Service Bulletin

Bulletin No.: 17-NA-402

Subject: No Crank/No Start/No Scan Tool Communication - Crank/No Start/No Fuel Pressure/
Fuel Pump Inoperative - Extreme Cold Weather

4868236

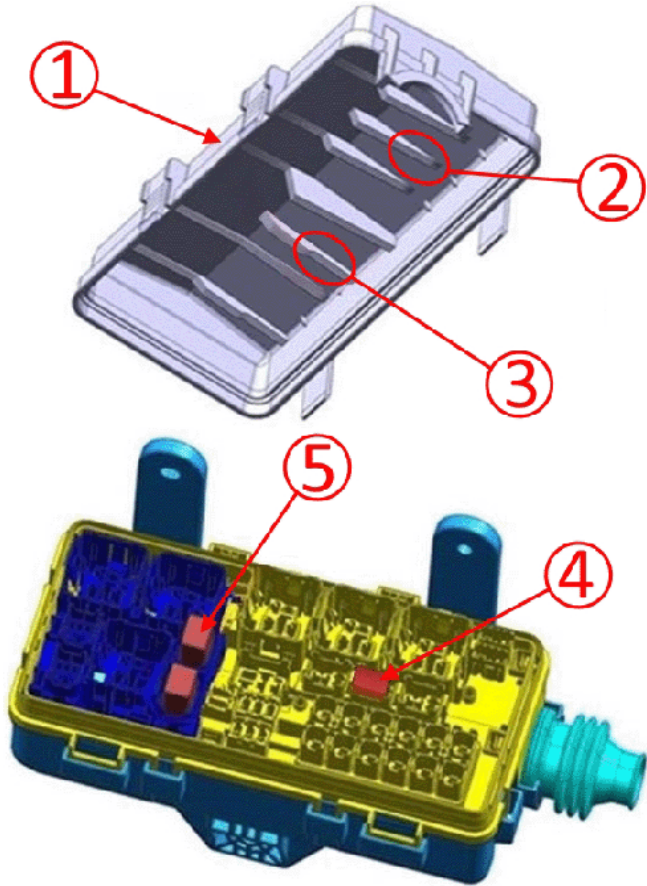
1. Remove the relay box cover (1).
2. Remove the original ECM Main Relay in locations X-22 or X-28.

3. Install the new relay at locations X-22 (4) or X-28 (5).
4. Locate the relay box cover rib(s) (2, 3).
5. Trim the relay cover rib(s) approximately 3 mm to provide clearance for the new relay(s).
6. Install the relay cover and confirm it seals properly.
 - If the cover does not close properly, trim additional material from the cover until it correctly seals.
